Submissions Report

STATE SIGNIFICANT DEVELOPMENT SSD-6026

Milk Processing Facility

111-113 Quarry Road, Erskine Park

Figure 1 Borehole Locations and Interpreted Groundwater Contours

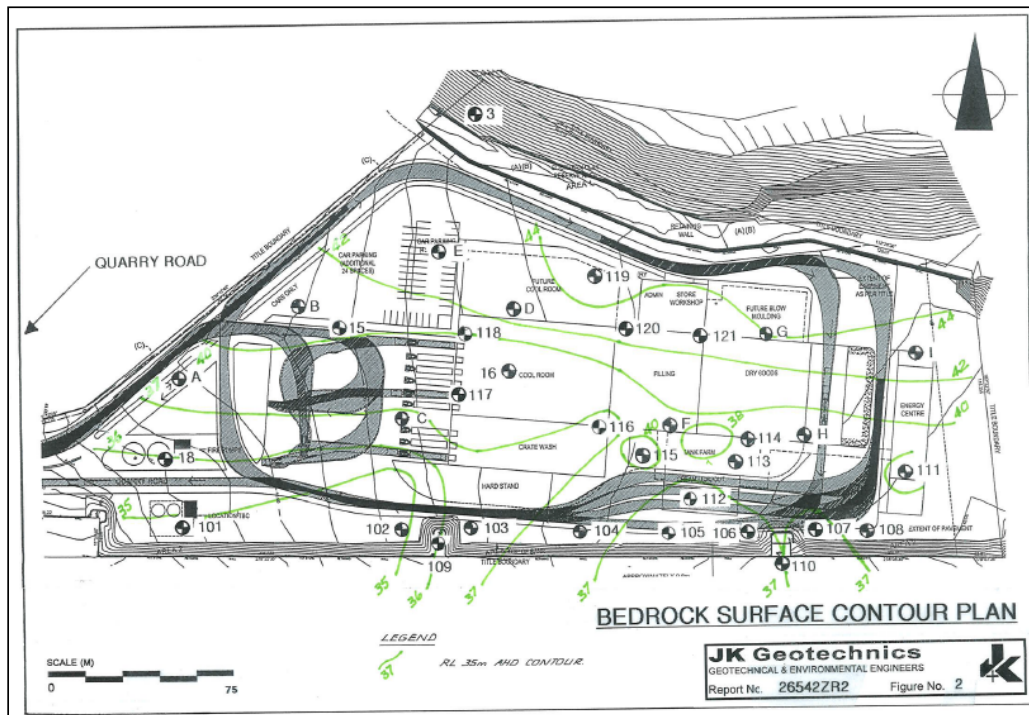
| Issues | Responses |
|--|---|
| <p>It is not clear if there will be an intersection of the Proposal with groundwater. While the EIS states groundwater occurs at depths greater than 20m below the ground surface (Volume 1, page 6-6-10), it predicts that seasonal perched water tables occur within the fill and the natural soils and the watertable depths are expected to fluctuate significantly in response to season and rainfall (Section 6.6.5, page 6-6-12). As such, the degree of fluctuation needs to be quantified.</p> | <p>The risks of works under the SSD approval intercepting groundwater, or causing groundwater pollution, are assessed as very low.</p> <p>The EIS states on page 6-6-12 the depths at which groundwater was encountered during geotechnical testing, as follows:</p> <p><i>"Groundwater seepage was only recorded in BH 101, BH 108, and BH 111 at depths of 13.5m, 6m and 6.5m, respectively. The remaining boreholes were 'dry' during auger drilling. On completion of auger drilling standing water levels were recorded at depths of 7.6m (BH 101), 10.3m (BH 103), 10.2m (BH 104), 8m (BH 106), 8.7m (BH 107), 6m (BH 109 & BH 110), 4m (BH 111), 7.4m (BH 116) and 6.6m (BH 119) within a few hours or after a maximum of 8 days following completion of auger drilling."</i></p> <p>The works to be undertaken under this SSD approval occur mainly above ground. Underground works involving excavation are limited to installation of the stormwater drainage system and services. These works would involve shallow excavations to depths generally less than 2m. This is significantly shallower than the depth at which groundwater was observed during geotechnical testing.</p> <p>(Note: a more detailed description of groundwater levels is provided in Appendix 1)</p> |

Borehole locations and interpreted groundwater contours are shown in Figure 1.

The groundwater observations are interpreted as evidence of a perched (or seasonal) groundwater table, caused by impeded drainage due to a low permeability horizon relatively deep within the soil profile. It should be noted that seasonal high water tables are a common feature of the clay soils derived on Wianamatta Group shales in Western Sydney as evidenced by the typically mottled colours of the subsoils. These mottled horizons often occur to within 300-500mm of the surface and are a product of impeded shallow drainage, and wetting and drying cycles in response to climatic conditions.

Figure 2 Geotechnical Section 1

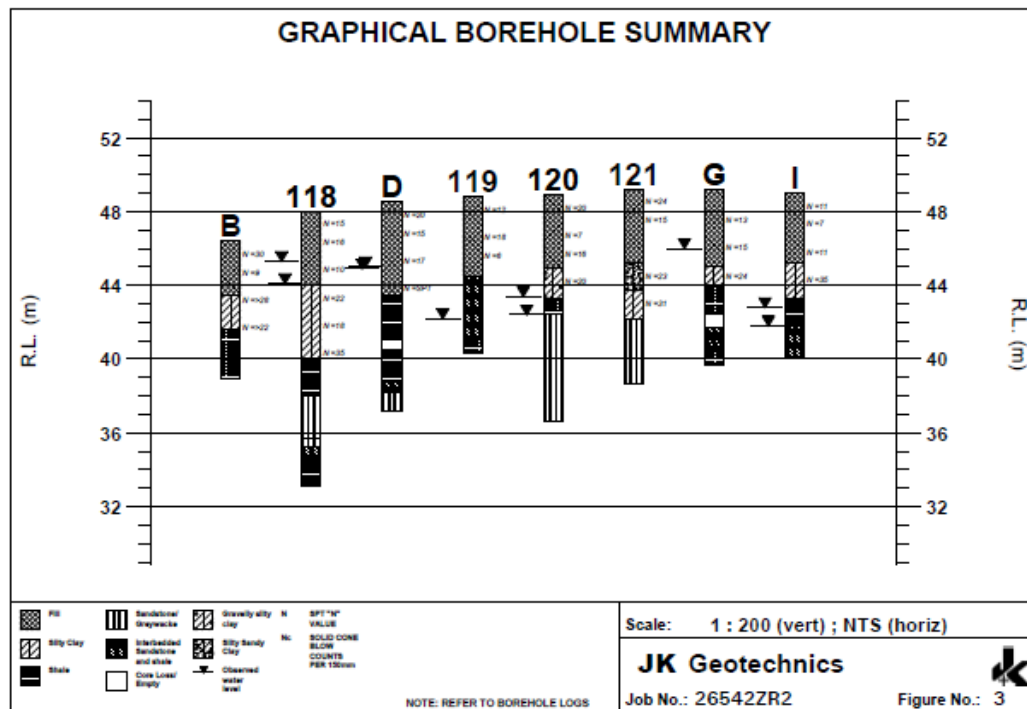
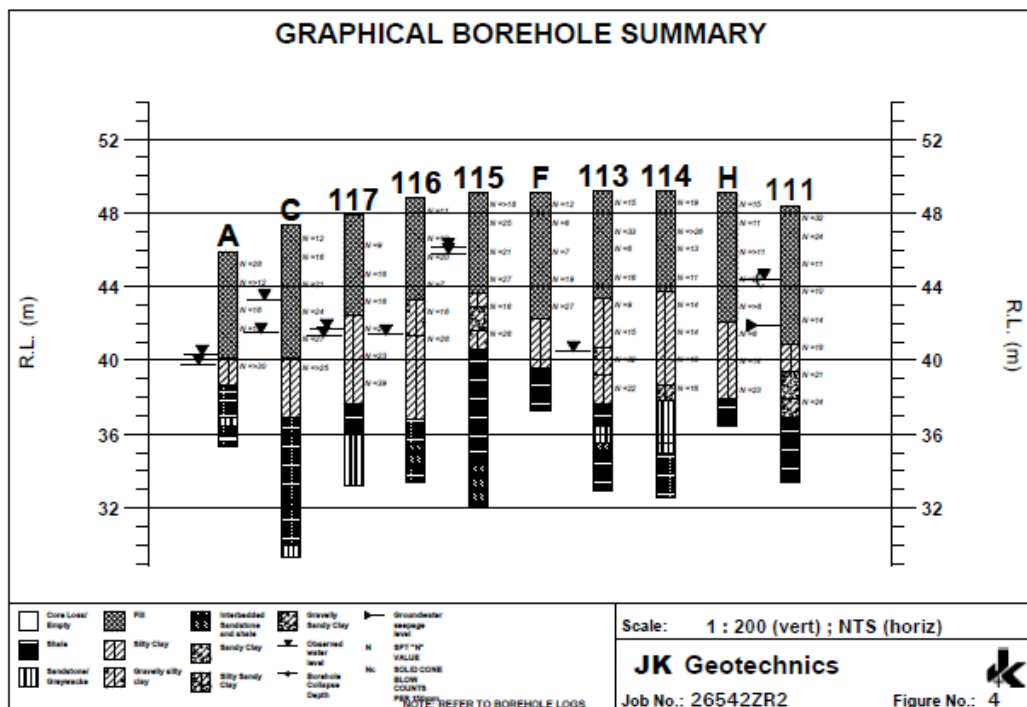
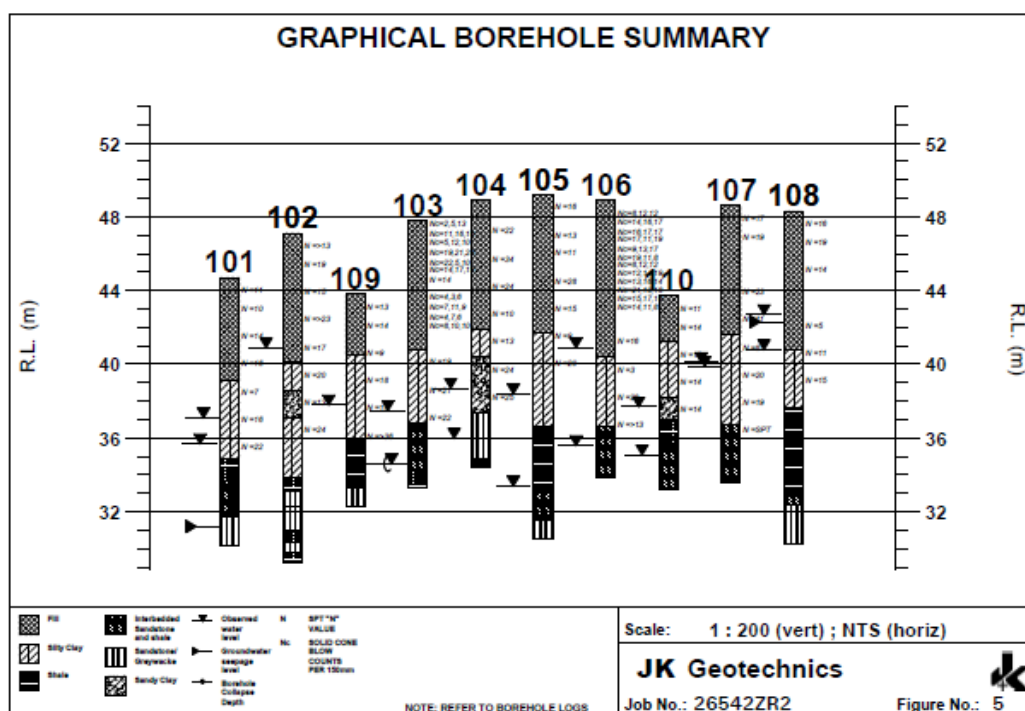
| Issues | Responses |
|--|---|
| <p>The excavation proposed for the Proposal is deemed to be an aquifer interference activity in accordance with the definition in the Water Management Act 2000. It is expected that the excavation and construction at the property will be conducted in accordance with the principles of the Aquifer Interference Policy.</p> <p>If groundwater is likely to be intercepted or extracted, depending on the volumes encountered and the duration of pumping, an authorisation may be required from the Office of Water in relation to construction excavation and dewatering activities. Consultation with the Office of Water is required to determine these requirements. The Office of Water can advise on the need for an authorization once information is available on the expected groundwater inflows.</p> | <p>The excavation does not represent an aquifer interference activity as it will not intercept groundwater.</p> <p>Observations during earthworks have noted that there was no interaction with groundwater, which was also predicted in the EIS.</p> <p>The works to be undertaken under this SSD approval occur mainly above ground. Underground works involving excavation are limited to installation of the stormwater drainage system and services. These works would involve shallow excavations to depths generally less than 2m. This is significantly shallower than the depth at which groundwater was observed during geotechnical testing.</p> <p>(Note: a more detailed description of groundwater levels is provided in Appendix 1)</p> |

This is significantly shallower than the depth at which groundwater was observed during geotechnical testing, as indicated in Figure 2, Figure 3 and Figure 4. Note that when viewing these cross-sections, surface levels have changed by as much as 1m in the central part of the site; however, there remains a significant vertical separation between the planned excavations works and the observed perched groundwater levels.

- No excavations deeper than the groundwater table are expected;
- The SSD project works and early works involve only superficial earthworks to level the site, and these changes are not expected to impact on groundwater conditions;
- The sediment basin has been lined to prevent seepage to groundwater;
- There are no planned stormwater infiltration measures and irrigation would be minimised during operations, to prevent groundwater levels being raised by the Project.

Appendix 2 - Stormwater Outlet Drawing

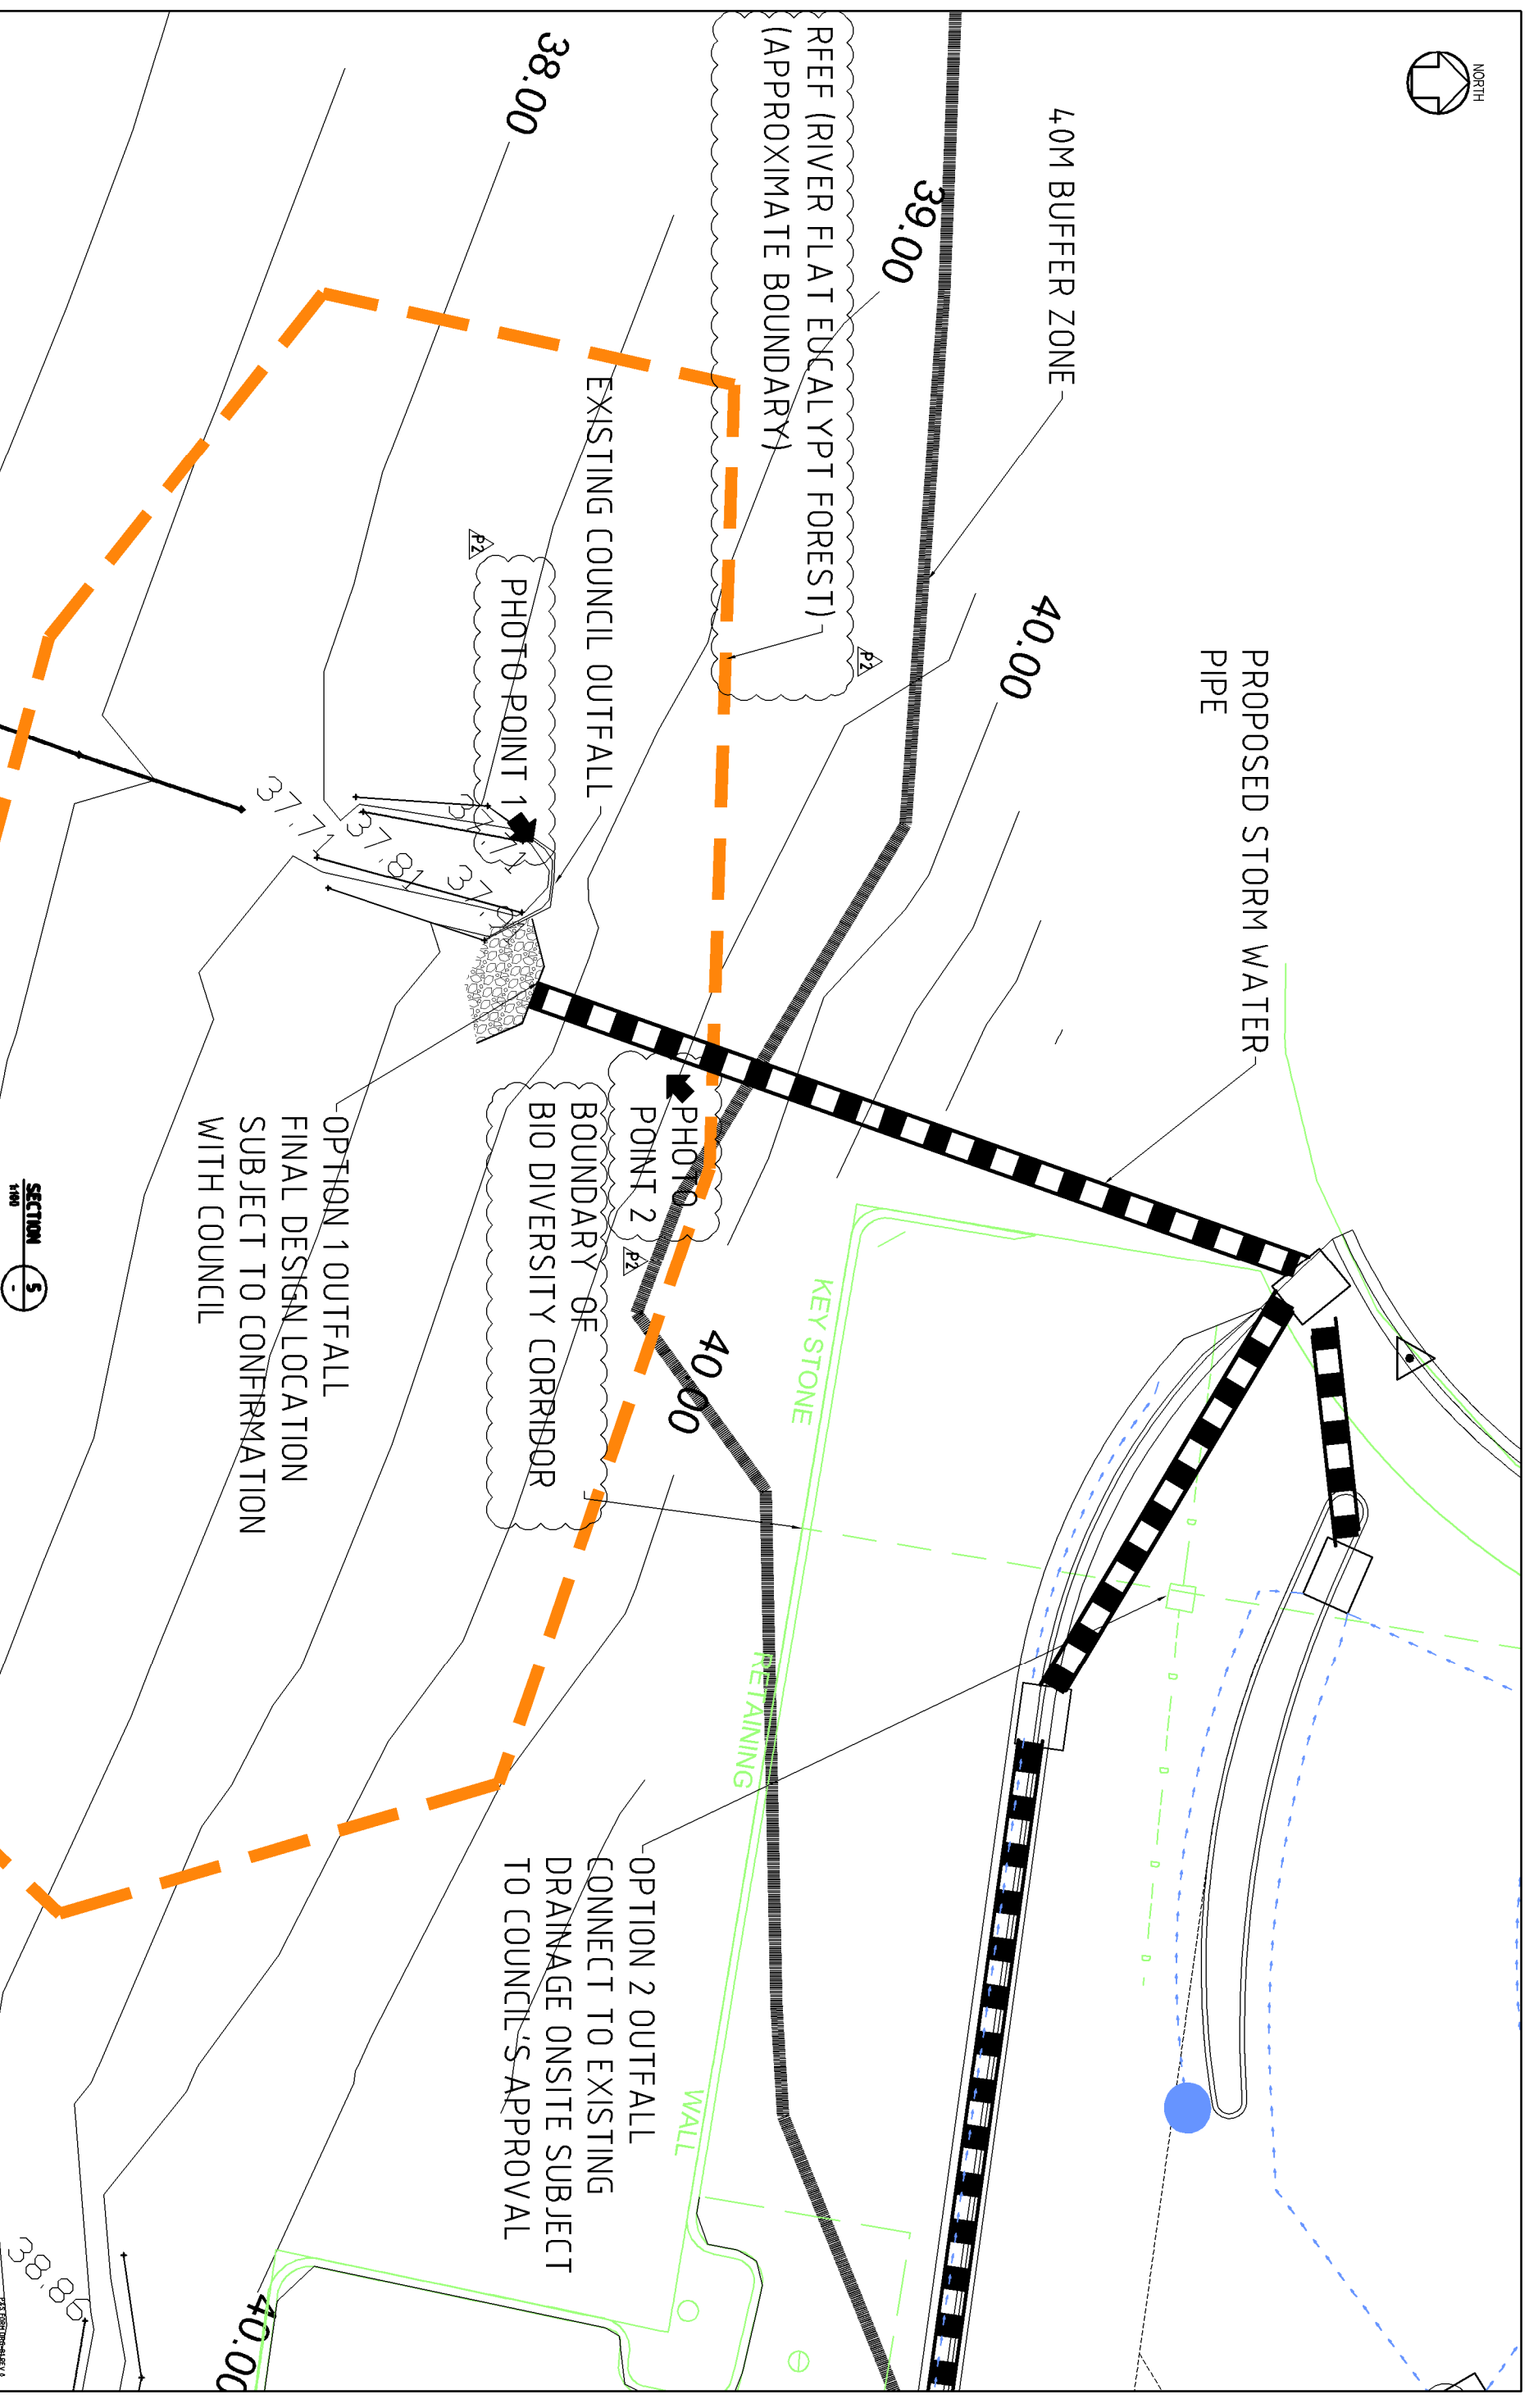
| Issues | Responses |
|---|--|
| <p>Clarification is required as to whether the proposal involves undertaking activities in, on or under waterfront land (i.e. in relation to stormwater works) and if so, what management measures will be implemented.</p> | <p>There is potential for stormwater drainage works to be undertaken on waterfront land, though the extent of this depends on the final stormwater outlet design. The stormwater discharge options (in order of priority) at the southwestern corner of the site are (refer to Appendix 2 and Appendix 3):</p> <ul style="list-style-type: none"> (i) To existing Council drainage network, subject to Council approval; and (ii) Provide a new outlet pipe to discharge in a similar location to the existing Council outlet, subject to detailed design and confirmation/approval of adjoining landowner. <p>The preferred stormwater discharge option involves connection to the existing Council drainage network and would involve no disturbance or activities in waterfront land. Council is yet to authorize this option, so the fallback option is to construct a new outlet.</p> <p>Works may also be required to improve the stormwater drainage along the eastern boundary to address an existing erosion issue where this stormwater discharges at the southeastern corner of the site over the existing retaining wall. These flows are predominantly generated offsite and discussions are being undertaken with adjoining landowners to confirm an approach to solving this issue.</p> <p>Any works within waterfront land would be undertaken in accordance with the Soil and Water Management Plan (SWMP) that will be prepared as part of the Construction Environmental Management Plan (CEMP). A progressive Erosion and Sediment Control Plan (PESCP) would be prepared for works in this area. Key environmental controls would include:</p> <ul style="list-style-type: none"> • Limiting disturbance to the minimum area practicable; • Installing sediment controls (eg sediment fence) downslope of the works; and • Promptly stabilizing the site upon completion of works to limit ongoing erosion. • A plan showing the layout of the stormwater outlet options is provided in Appendix 2 and photographs of the location with the outlet structure overlaid are provided in Appendix 3. |

| Issues | Responses |
|--|--|
| <p>Appendix 3 of Technical Paper TP3 notes the stormwater outlet location is within cleared lands and River-Flat Eucalypt Forest (page 34). The Office of Water recommends the following:</p> <ul style="list-style-type: none"> The stormwater outlet structure placed to avoid disturbing remnant native vegetation. A scaled plan, which shows the location of: <ul style="list-style-type: none"> The proposed stormwater structure route. The creek and top of the bank. The boundary of the Biodiversity Corridor. Remnant vegetation potentially affected by the outlet structure. | <p>The preferred stormwater discharge option involves connection to the existing Council drainage network and would involve no disturbance or activities in waterfront land (refer to Appendix 2). Council is yet to authorize this option, so the fallback option is to construct a new outlet.</p> <p>The new outlet structure would be located near the existing Council outlet and would involve only minimal clearing of native vegetation within the River Flat Eucalypt Forest, as shown in Appendix 3. The vegetation likely to be disturbed is relatively young regrowth. The new outlet structure would be primarily located in a grass strip area as shown in Appendix 3.</p> <p>Appendix 2 indicates the stormwater structure route and the boundary of the biodiversity corridor. The impact on remnant vegetation is described above and illustrated in Appendix 3. Appendix 4 provides a survey of the creek.</p> |
| <p>The outlet structure should be in accordance with the Office of Water Guidelines for Outlet Structures on Waterfront Land (June 2012).</p> | <p>The outlet structure will be designed and constructed in accordance with the Office of Water Guidelines for Outlet Structures on Waterfront Land (June 2012).</p> |
